HILLINGDON GARDENS

DESIGN UPDATES

GREATER LONDON AUTHORITY

Job Number: 19011
Document Revision: P4
Date of Issue: 16.06.2020
Purpose of Issue: Planning
Key Personnel: FvB
Reviewed by: RC
Review Date:

2.1. BUILDING 1 ELEVATIONS

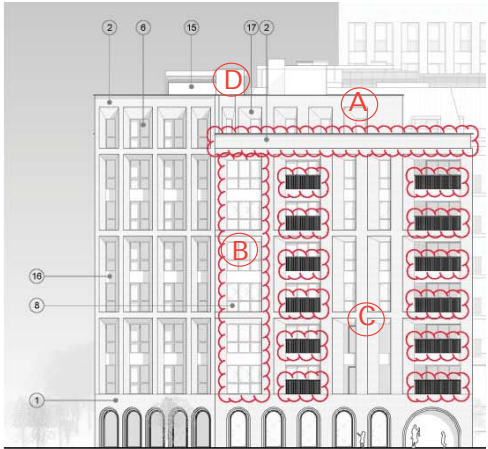
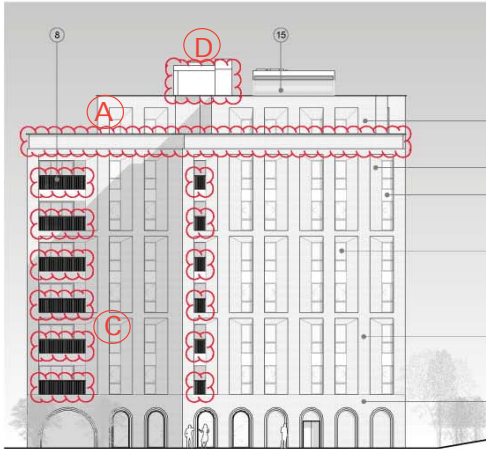
- A_Sixth floor parapet to perimeter terraces increased to meet AD Part K height and omit metalwork balustrading.
- B_Refined window design with reduced transparent glass areas in line with overheating requirements.
- C_Recessed balconies updated to provide containment with metal balustrading to suit new building regulations in lieu of laminate glass.
- D_Permanent maintenance access from stair core added and indicated residential plant requirements.

2.2. BUILDINGS 2,3,4 GROUND FLOOR PLAN

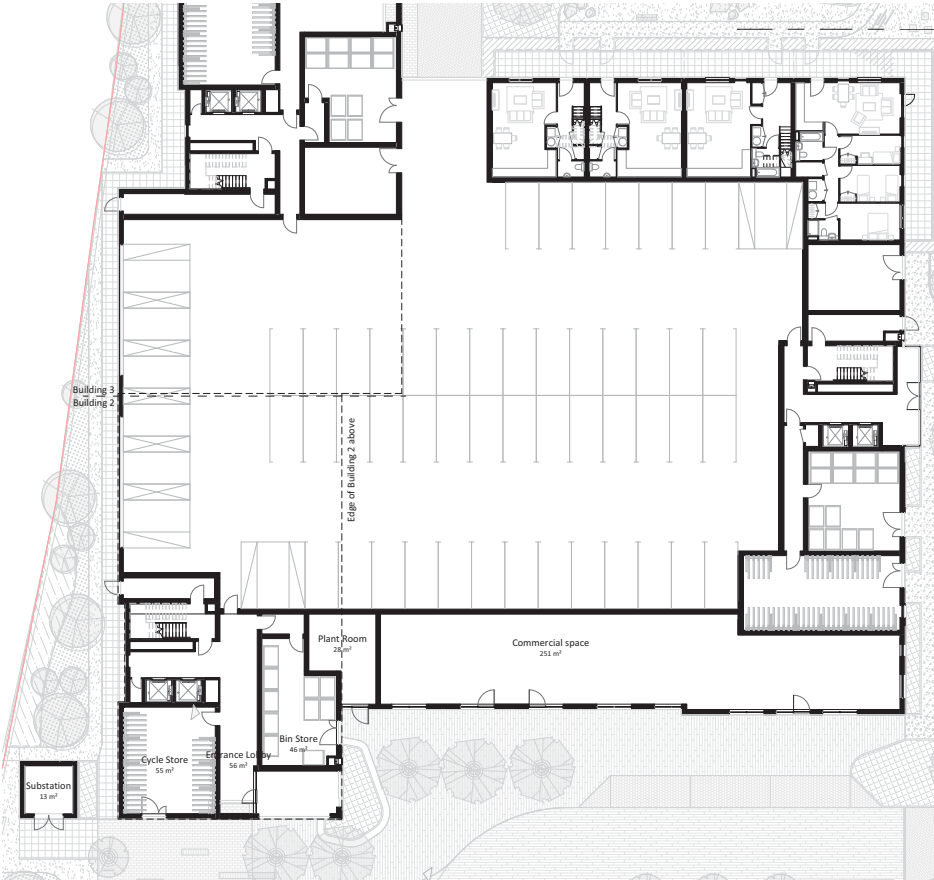
- A_Natural car park ventilation provisions provided with louvre screened penetrations and podium telescopic vent.
- B_Potential sub-divisions with commercial spaces indicated.

2.4. BUILDING 4 PLANS

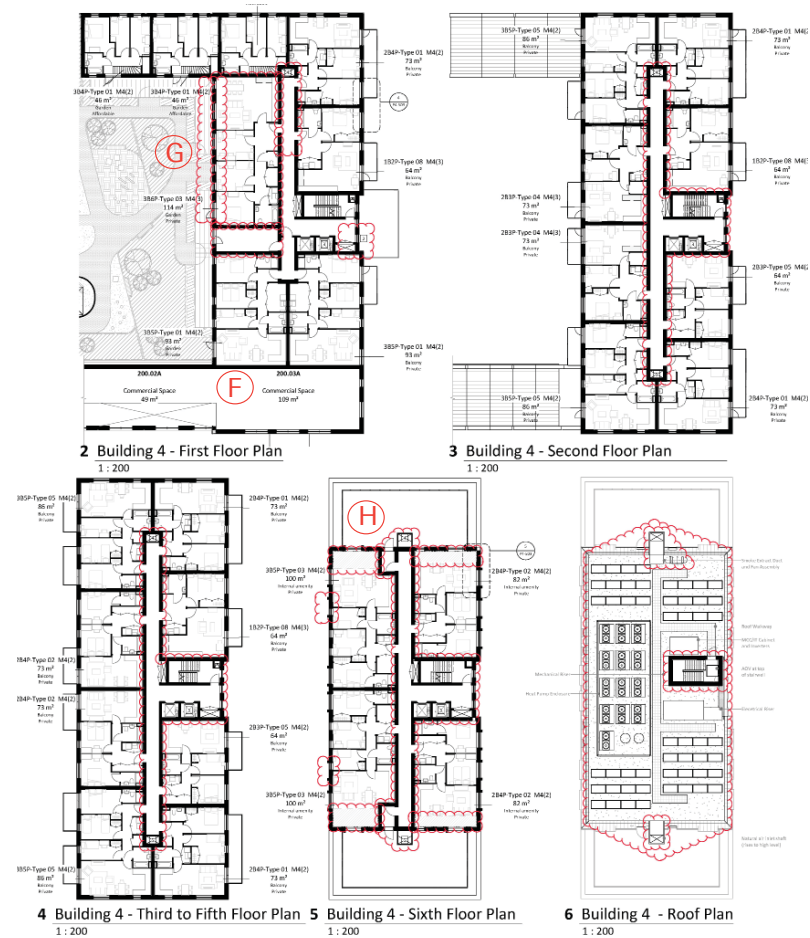
F_Small decrease of 77sq.m to commercial total.

G_2 No units in B4 (401.03 & 401.04) replaced with 3B6P retaining 514No. total units (to suit Building 2 updated for podium access).

H_Internal amenity update to sixth floor units due to soffit servicing zone allowances to units beneath

2.5. BUILDING 2&3 ELEVATIONS

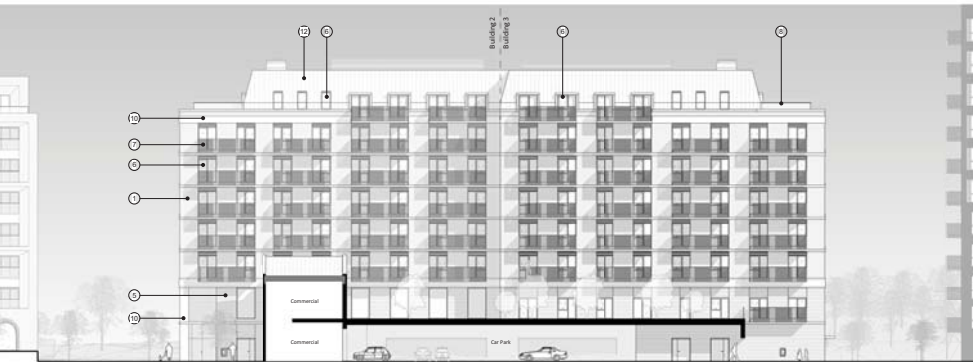
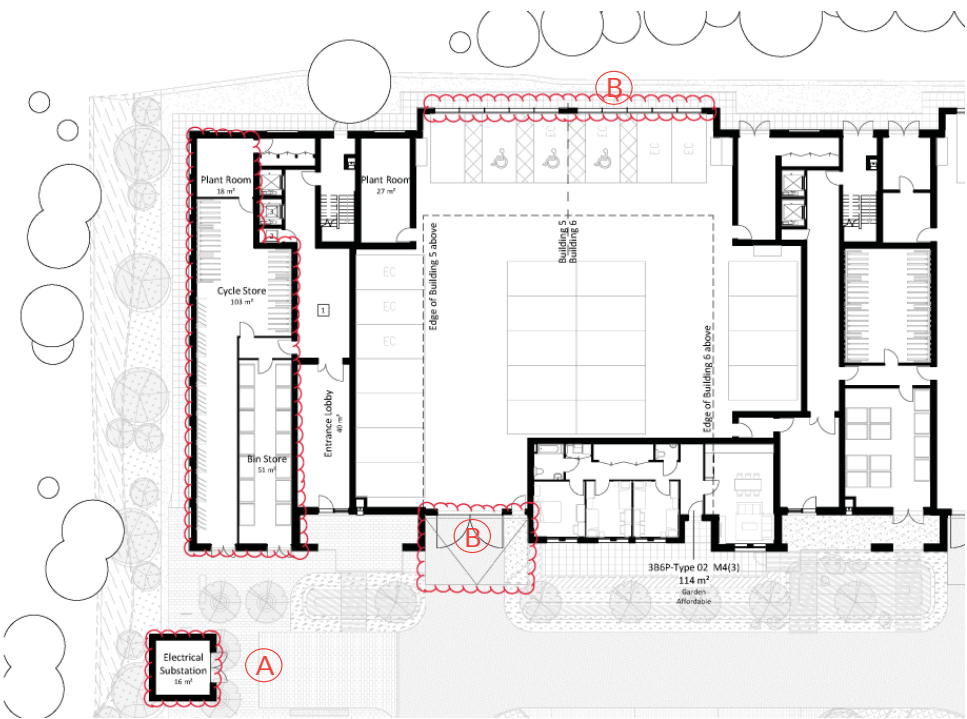
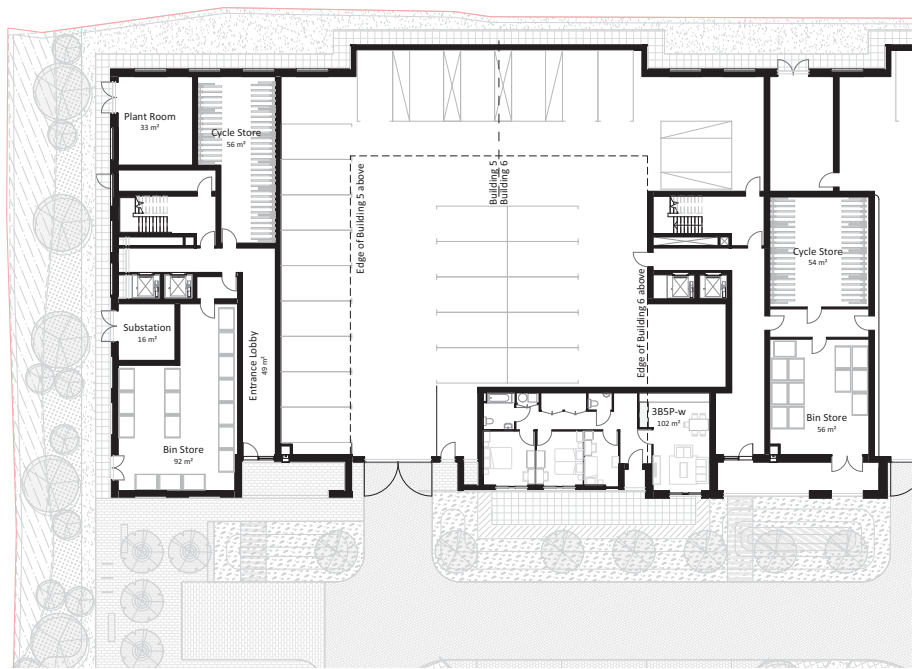
A_ B2 & B3 glass balustrading on rooftop terrace areas swapped in favour of metal balustrading to meet non-combustible building regulations.

B_ Refined window design with reduced transparent glass areas in line with overheating and DSL requirements.

2.7. BUILDING 5 ELEVATIONS

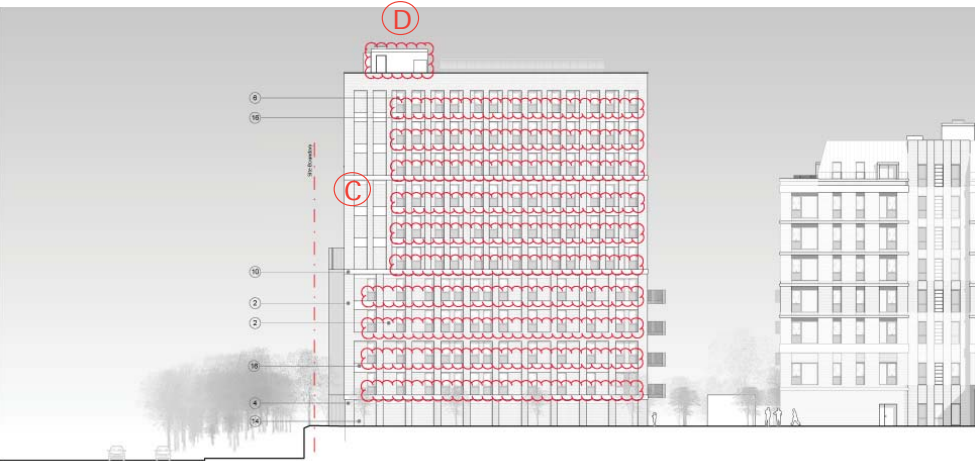
- C_ Refined window design with reduced transparent glass areas in line with overheating requirements.
- D_ Permanent maintenance access from stair core added and indicated residential plant requirements.

2.8. BUILDING 6 PLANS

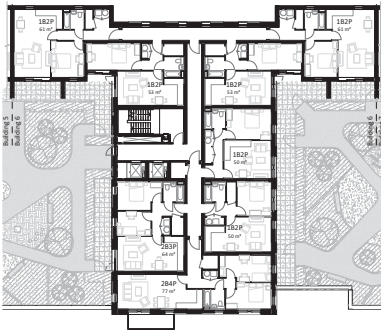
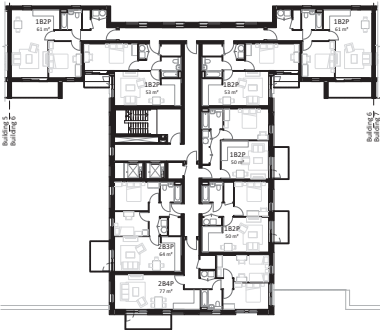
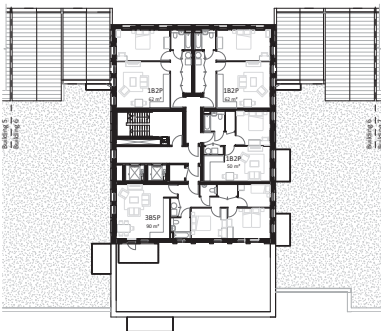
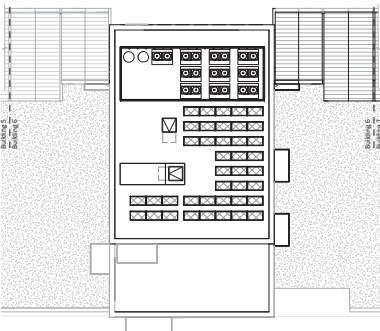
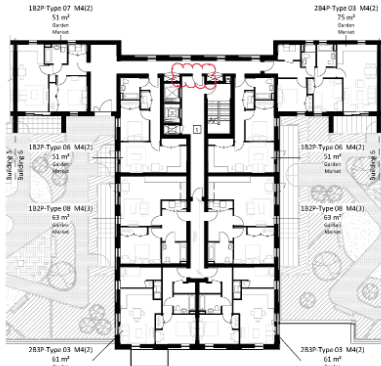
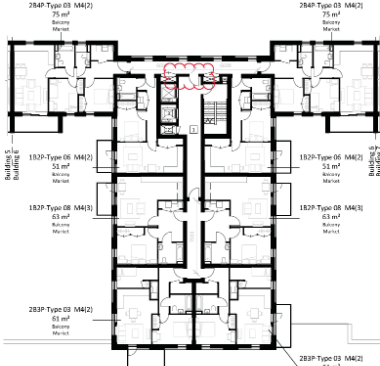
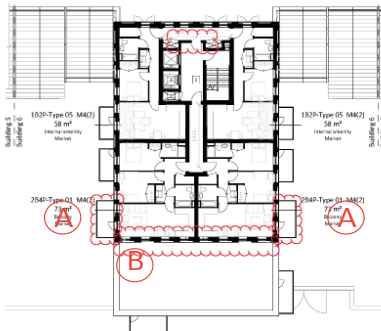
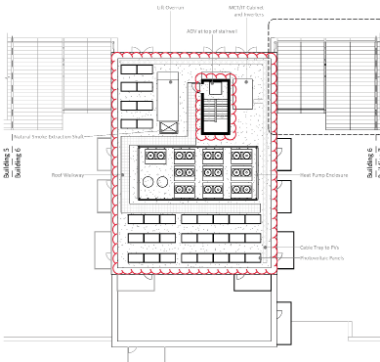
A_6 No. units at 5th floor levels now with balcony amenity space in lieu of mid-rooftop terraces (plots 605/705/805.01 & 02).

B_6 No. units at 6th & 7th floor levels swapped onto south elevations to match adjacent plots and provide preferable amenity space (plots 606/607/706/707/806/807.01).

2.9. BUILDING 6 ELEVATIONS

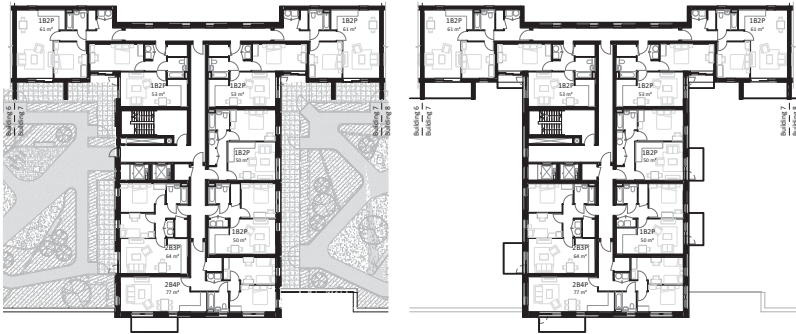
C_Permanent maintenance access from stair core added and indicated residential plant requirements.

D_Reduced metal balustrading to buildings at fifth floor roof area, parapet heights retained and fall restraint lines to be used for maintenance.

E_Refined window design with reduced transparent glass areas in line with overheating requirements.

2.10. BUILDING 7 PLANS

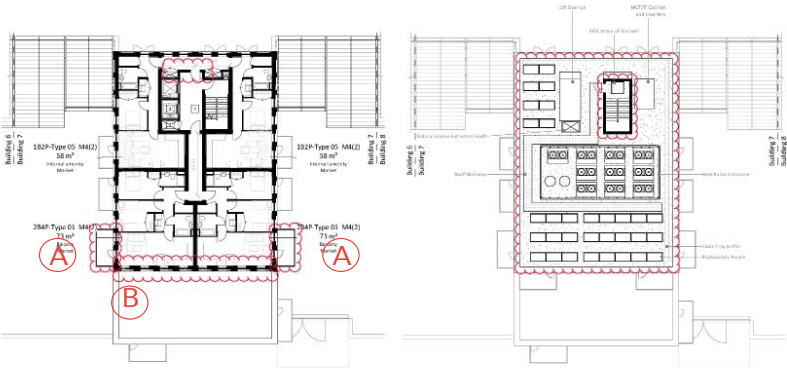
A_6 No. units at 5th floor levels now with balcony amenity space in lieu of mid-rooftop terraces (plots 605/705/805.01 & 02).

B_6 No. units at 6th & 7th floor levels swapped onto south elevations to match adjacent plots and provide preferable amenity space (plots 606/607/706/707/806/807.01).

2.11. BUILDING 7 PLANS

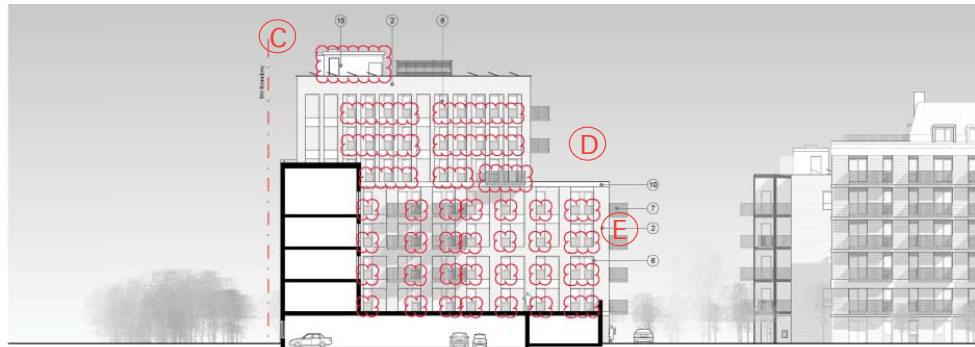
C_Permanent maintenance access from stair core added and indicated residential plant requirements.

D_Reduced metal balustrading to buildings at fifth floor roof area, parapet heights retained and fall restraint lines to be used for maintenance.

E_Refined window design with reduced transparent glass areas in line with overheating requirements.

2.12. BUILDING 8 PLANS

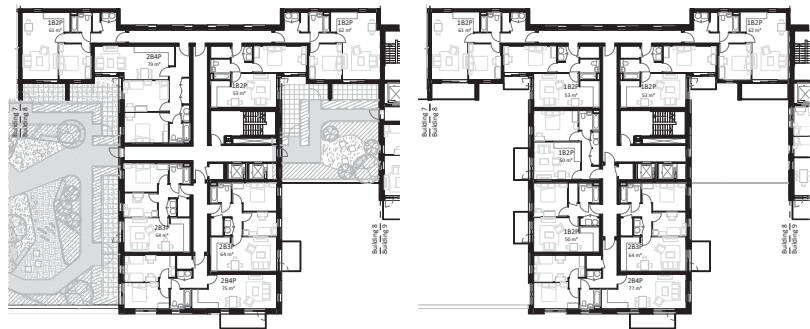
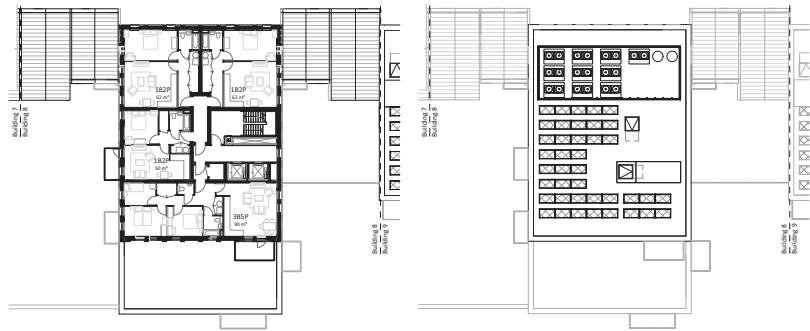
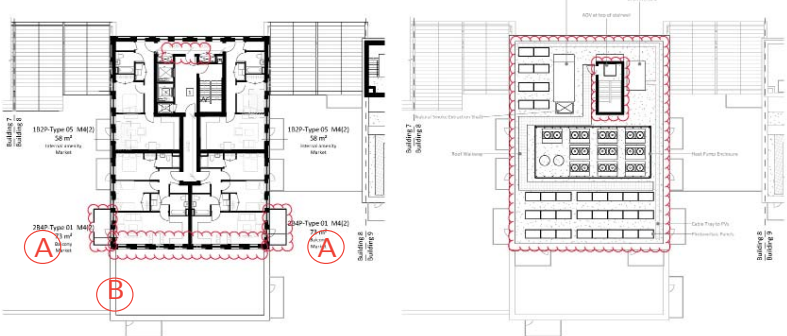
A_6 No. units at 5th floor levels now with balcony amenity space in lieu of mid-rooftop terraces (plots 605/705/805.01 & 02).

B_6 No. units at 6th & 7th floor levels swapped onto south elevations to match adjacent plots and provide preferable amenity space (plots 606/607/706/707/806/807.01).

C_Permanent maintenance access from stair core added and indicated residential plant requirements.

2.13. BUILDING 8 ELEVATIONS

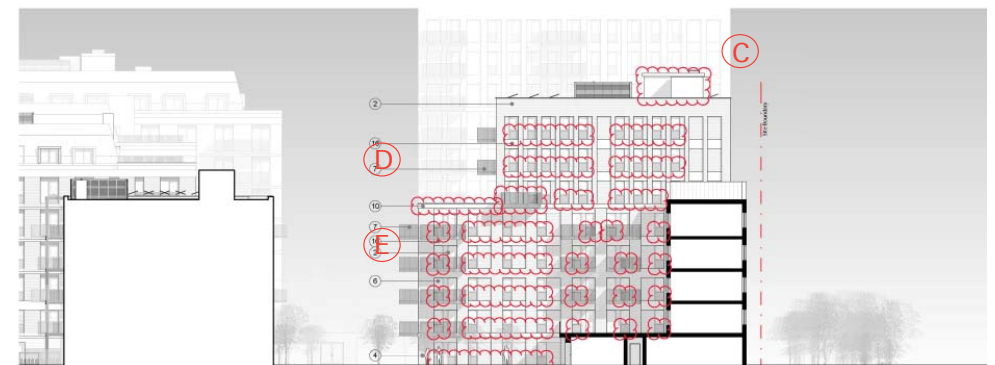
C_Permanent maintenance access from stair core added and indicated residential plant requirements.

D_Reduced metal balustrading to buildings at fifth floor roof area, parapet heights retained and fall restraint lines to be used for maintenance.

E_Refined window design with reduced transparent glass areas in line with overheating requirements.

2.14. BUILDING 9 PLANS

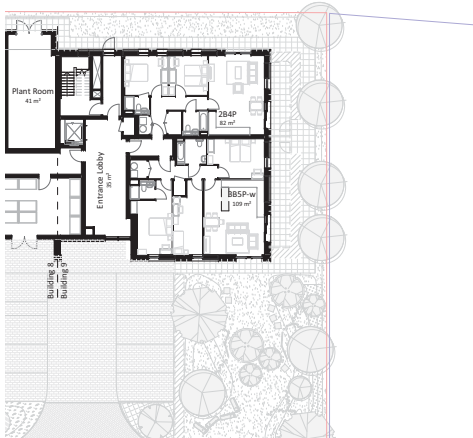
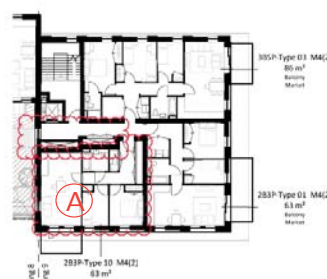
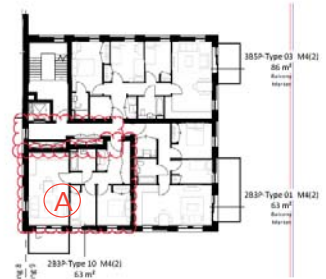
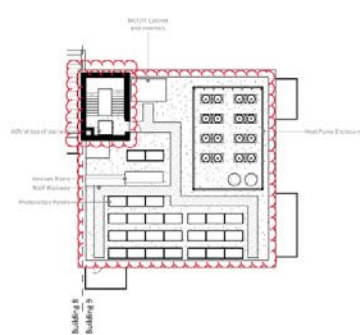
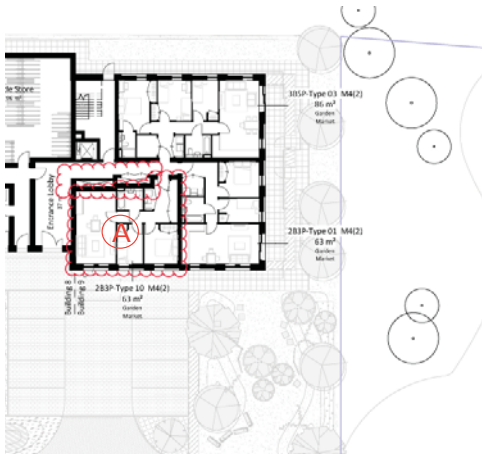
A_2B3P replacing 1B2P-W units as per previous directive on disabled access/parking.

2.15. BUILDING 9 ELEVATIONS

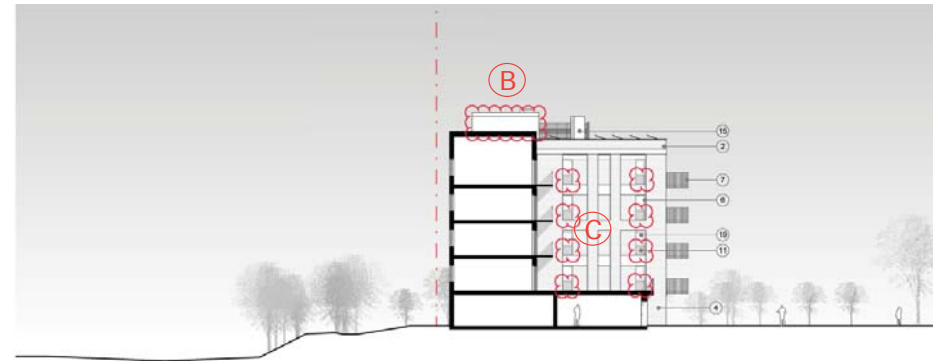
B_Permanent maintenance access from stair core added and indicated residential plant requirements.

C_Refined window design with reduced transparent glass areas in line with overheating requirements.

2.16. BUILDING 10 PLANS

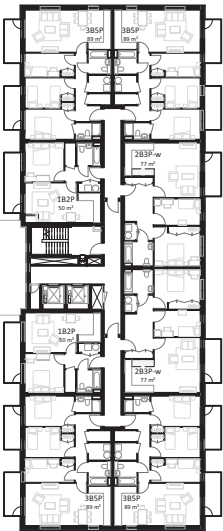
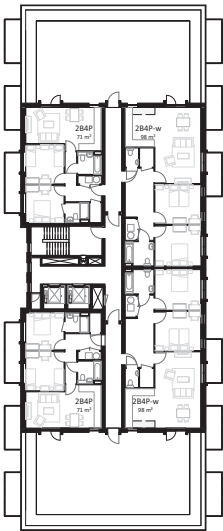
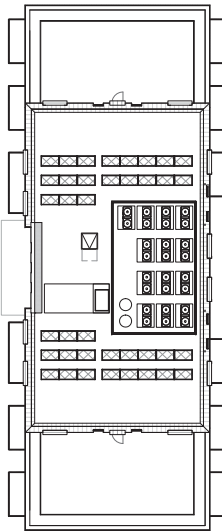
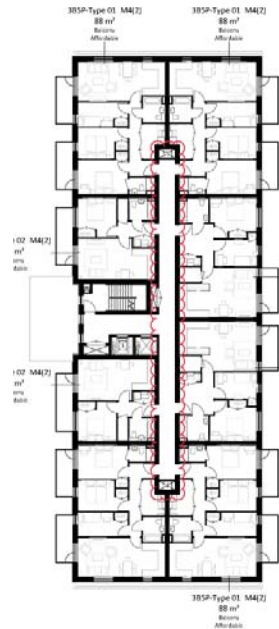
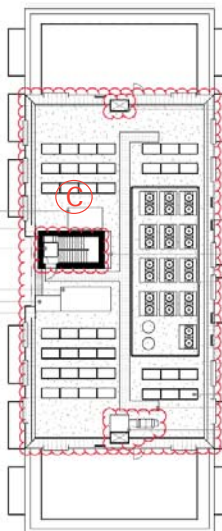
A_Glass balustrading on rooftop terrace areas swapped in favour of metal balustrading non-combustible building regulations.

B_2 No. sixth floor units windows reduced to coordinate internal partitions between KLD and Bed3.

C_Permanent maintenance access from stair core added and indicated residential plant requirements.

D_Internal amenity update to sixth floor units due to soffit servicing zone allowances to units beneath

2.17. BUILDING 10 ELEVATIONS

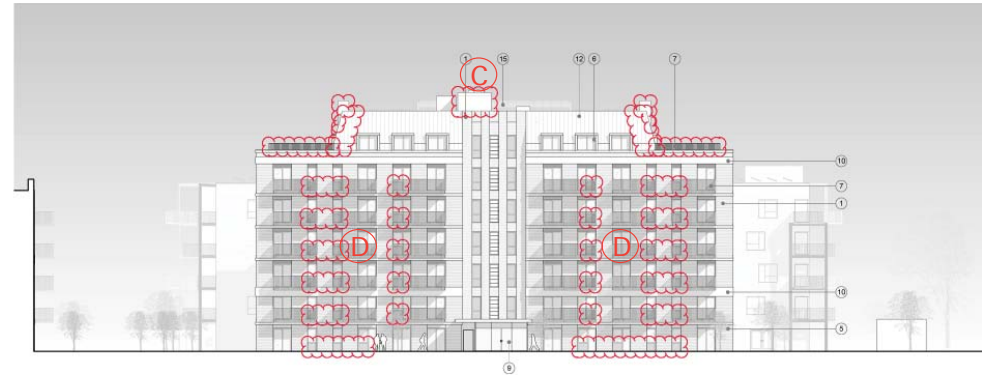
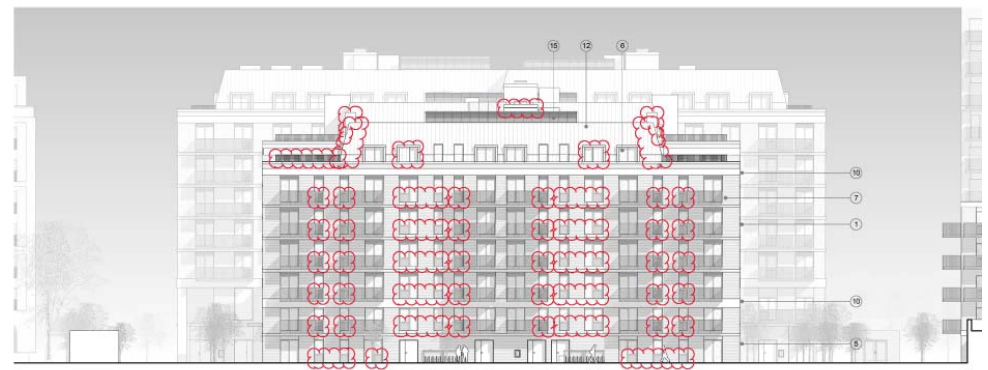
C_Permanent maintenance access from stair core added and indicated residential plant requirements.

D_Refined window design with reduced transparent glass areas in line with overheating and DSL requirements.
